STAFF REPORT
CITY OF BEVERLY HILLS

**For the Design Review Commission
Meeting of May 6, 2010**

SUBJECT: A request for an R-1 Design Review Permit to allow the construction of a new two-story single-family residence, located in the Central Area of the City, south of Santa Monica Boulevard at **126 North Maple Drive. (PL 101 0459)**

Previous Design - Project Preview - 4/1/10

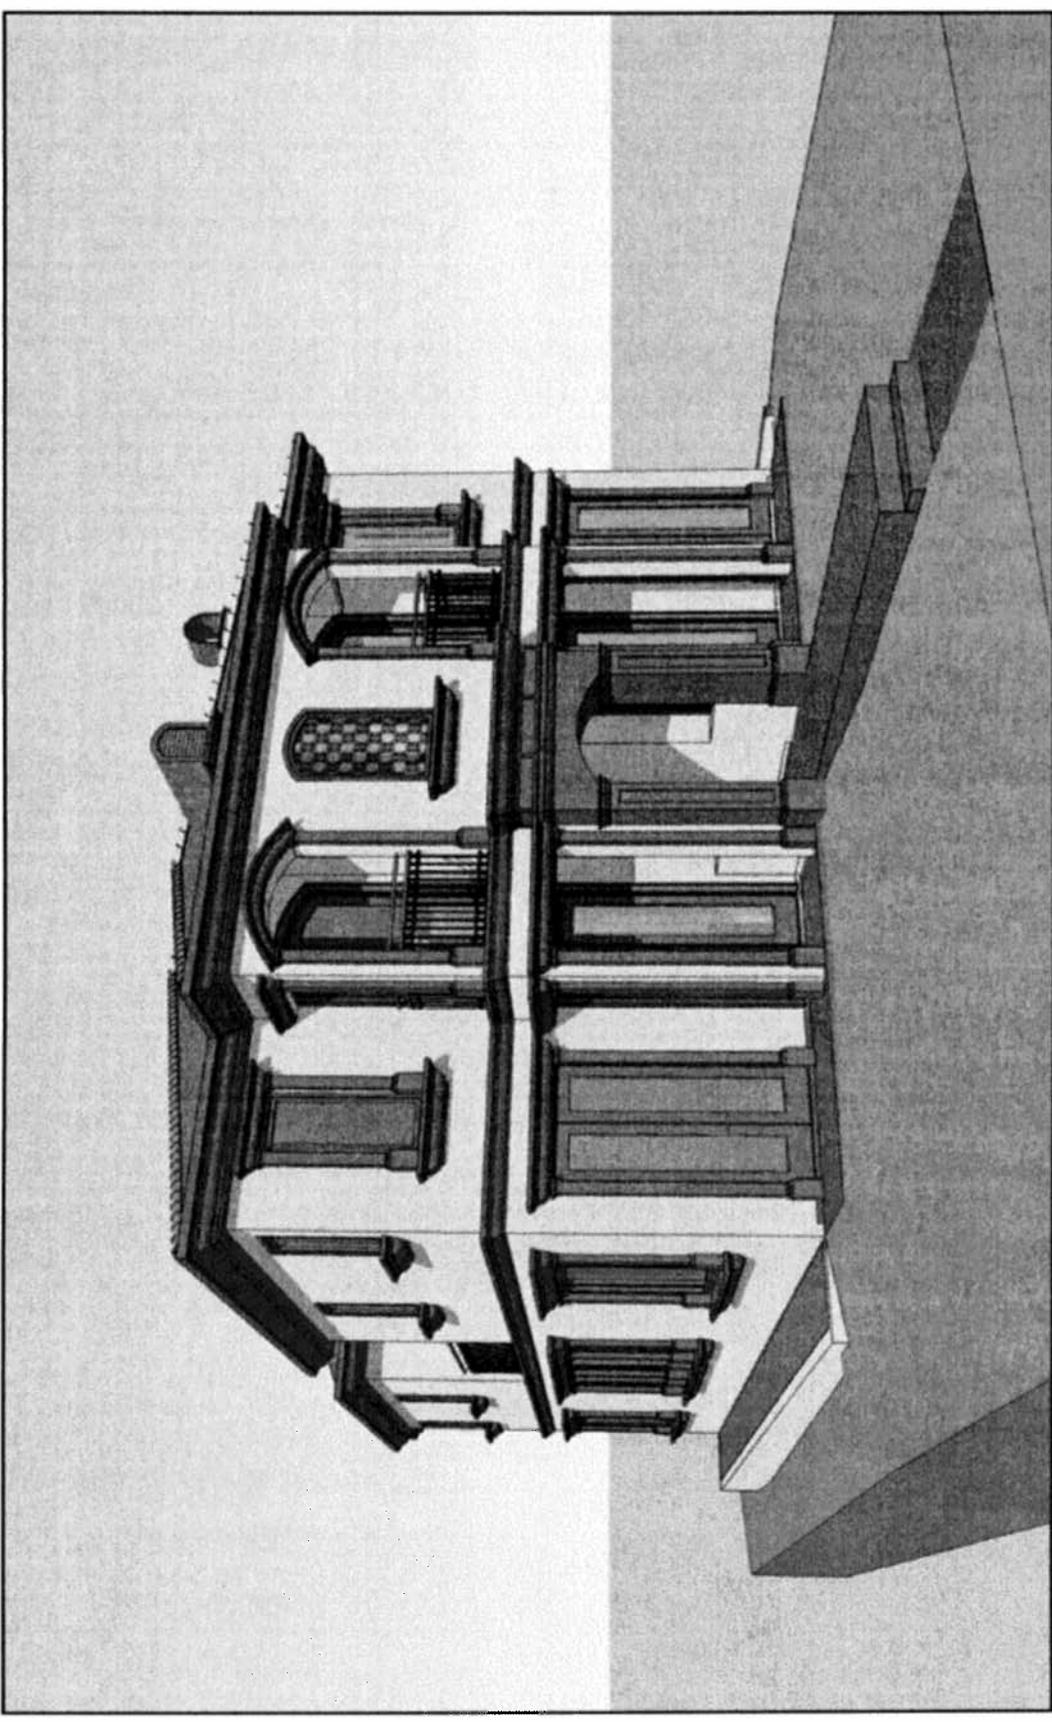
- The proposed fence design was different on the rendering and PowerPoint. These should be reconciled.
- The applicant confirmed that the sideyard wall would be finished with stucco over the existing brick.

- The question was raised as to whether there would be landscaping in the front yard. The applicant stated that there was no landscaping proposed due to the large parkway tree. Suggestions from the Commission included adding a boxwood hedge along the front property line and adding cypress or other trees to complement the architectural style. Symmetry was not necessarily desired – and Palladian styles could be looked at to help decide what types of landscaping might be appropriate.

- It was suggested that additional space be provided between the top of the windows on the first floor and the second floor line, as well as the windows on the first floor and the roofline.

- It was suggested that the arches along the front section of the façade could be deeper.
- Horizontal mullions were suggested for all of the windows.
- It was suggested that since the window over the front door serves as a focal point, it could be smaller and deeper.

- Concern was addressed about the use of green slate as the roofing material as it is very prominent and an alternative might be explored.
- It was suggested that the stucco color could be a warmer tone (perhaps in a more brown than yellow range).

- Concern was expressed about the wrought iron front door and that a combination of dark wood, metal and glass might be considered. A request was made that the applicant bring a sample of the proposed front door to the hearing on the item.

Revised Design – 5/6/10

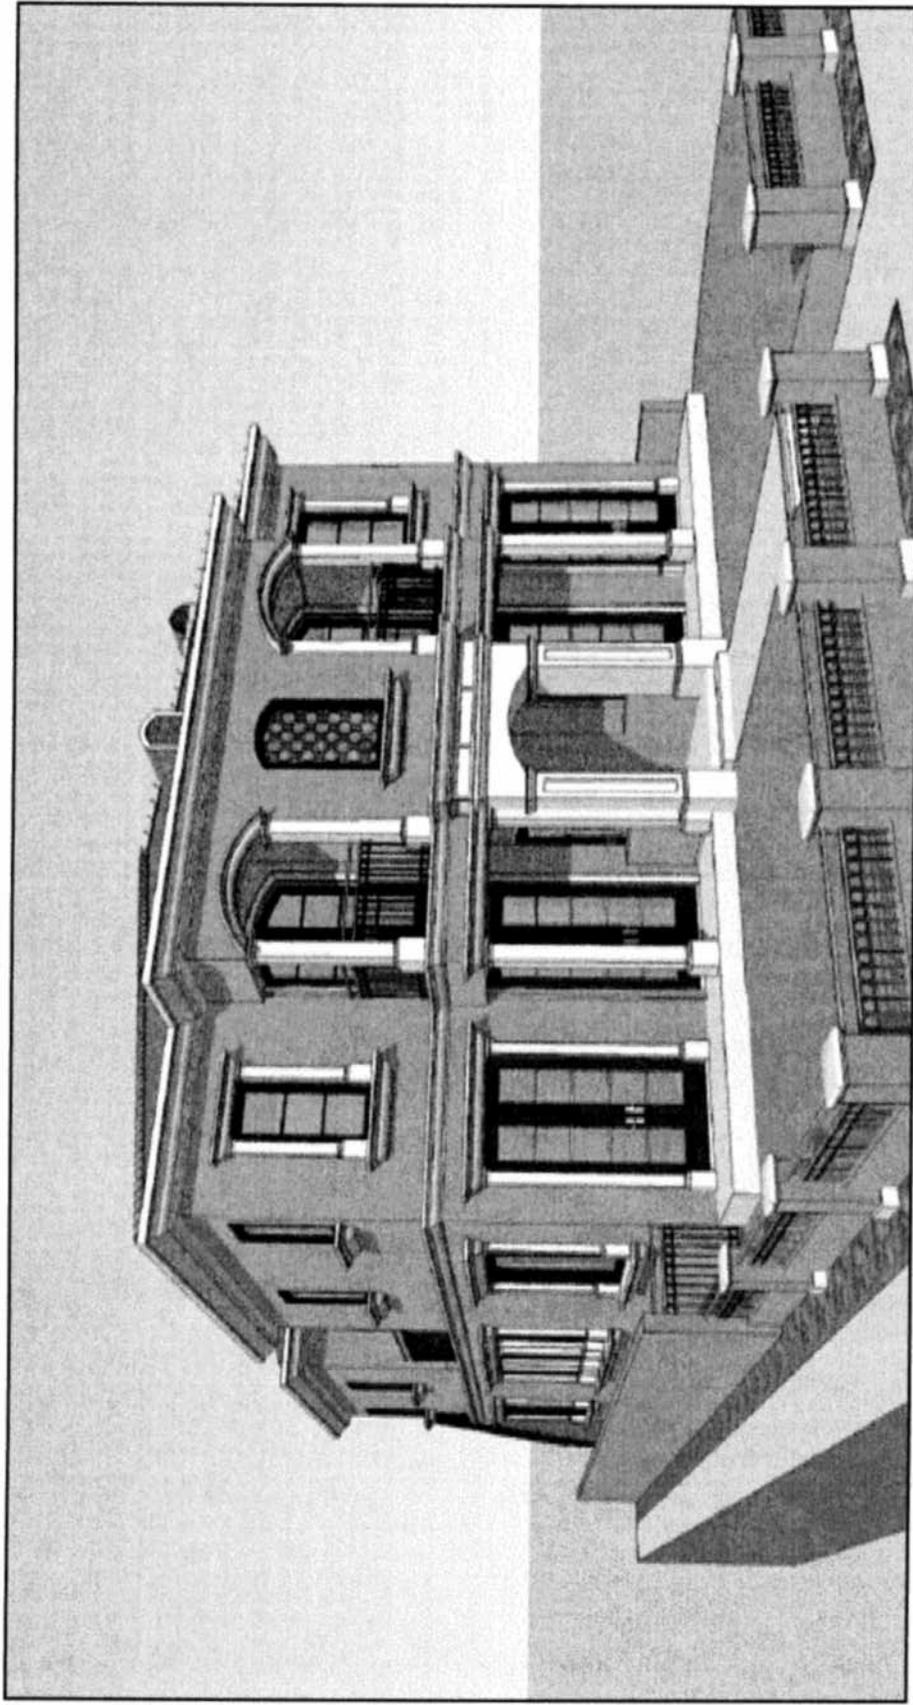
It does not appear to staff that each of these concerns was fully addressed. This is in part due to the following sequence of plan changes:

3. The plans submitted for the May meeting did not highlight the changes made as a result of the preview hearing. Due to the late timing of the submittal, staff did not have sufficient time to thoroughly analyze each of the changes. However, in the interest of time for the property owner, this item has been placed on the May agenda in order to avoid further delays in the processing of this application. Staff has requested that the applicant fully describe the project, including how the suggestions of the Commission have been incorporated into the current plans, at the May Commission meeting so that they can be fully addressed at the public hearing.

1. A revised landscape plan shall be prepared by a licensed landscape architect and returned to staff for final review and approval. Said plan shall comply with the City's water efficient landscaping requirements and include an appropriate mix of mature trees (48" box minimum size), low plantings and groundcover.
2. Any approval by the Commission is for design only; the project is subject to all applicable City zoning regulations.
3. Final plans shall include spec sheets for windows and call-outs on a colored elevation for each material proposed for verification in the field during construction.
4. Any future modifications to this approval shall be presented to staff for a determination as to whether the change may be approved by staff (minor) or to the Commission for review.
